City of Canby

Staff Report
File #: DR 23-03 & CUP 23-01
Clackamas County Fairgrounds Multipurpose Building

HEARING DATE: January 8, 2024
STAFF REPORT DATE: December 29, 2023
TO: Planning Commission
STAFF: Emma Porricolo, Associate Planner

Figure 8. North (Partial) and West Façade Elevations

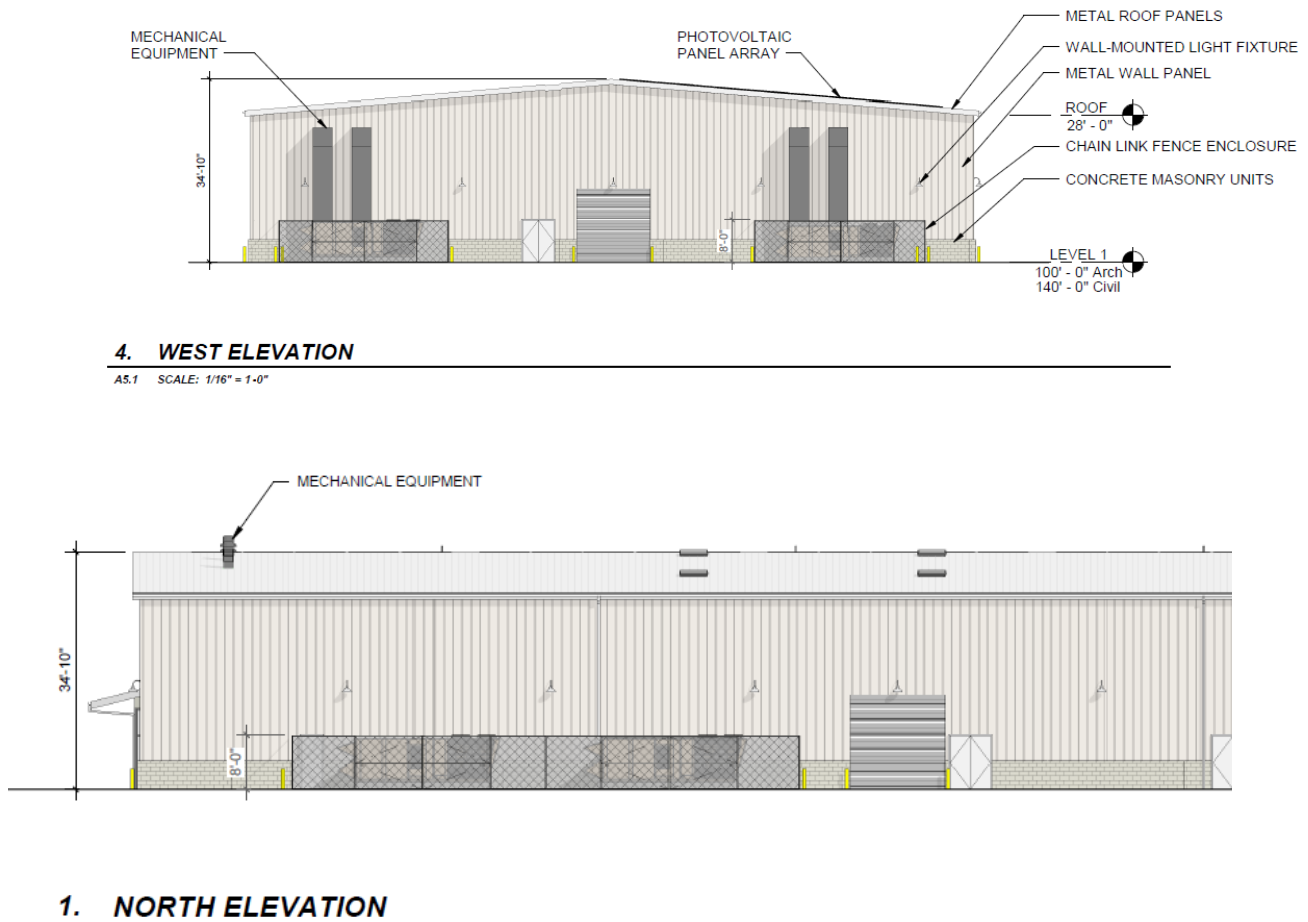
Finding 2: The proposed development includes an 8-foot-tall chain link fence around the exterior mechanical equipment on the north and west facades. Fences taller than 6 feet are not permitted in the R-1 zone. However, 8-foot-tall fences are permitted in certain commercial and industrial zones in the City (C-2, C-M, M-1, and M-2).

The proposed 8-foot chain link fence would be located around the mechanical equipment on the north and west façade of the building. On the west façade, the mechanical equipment extends 25 feet tall; whereas, on the north façade the equipment is approximately 8 feet tall (see Figure 8). The 8-foot chain link fencing would provide screening for the mechanical equipment as well as reduce noise and glare of the mechanical equipment. It would also provide better safety for patrons. Patrons would be better protected by an 8-foot fence, which would keep patrons and the mechanical equipment better separated. The additional separations also helps keep debris away from the air handling units which could help protect the equipment and keep the area cleaner and safer for ongoing and regular maintenance needs.

Staff concurs that the request to permit the 8-foot-tall fence to be within the purview of a CUP (CMC 16.50.404.J) and are supportive of the request given the reasons outlined by the applicant. Staff recommend Planning Commission approve the request to permit the 8-foot-tall fence around the mechanical equipment for the proposed multipurpose building. Given the size of the campus, if approved, Staff suggest Planning Commission clearly define where the fence height exemption is applicable.

Finding 32: The applicant is proposing an 8-foot-tall chain-link fence enclosures around the exterior mechanical equipment (see Figure 8). The R-1 zone allows for fences up to 6 feet tall. The applicant requests that the Planning Commission designate the 8-foot-tall chain-link fence enclosures as permitted under their review and approve the fence enclosures as proposed in this application. Per CMC 16.50.404.J., Planning Commission may designate the size, height, location, and materials for a fence. For more information on the proposed fencing, see Finding 2.
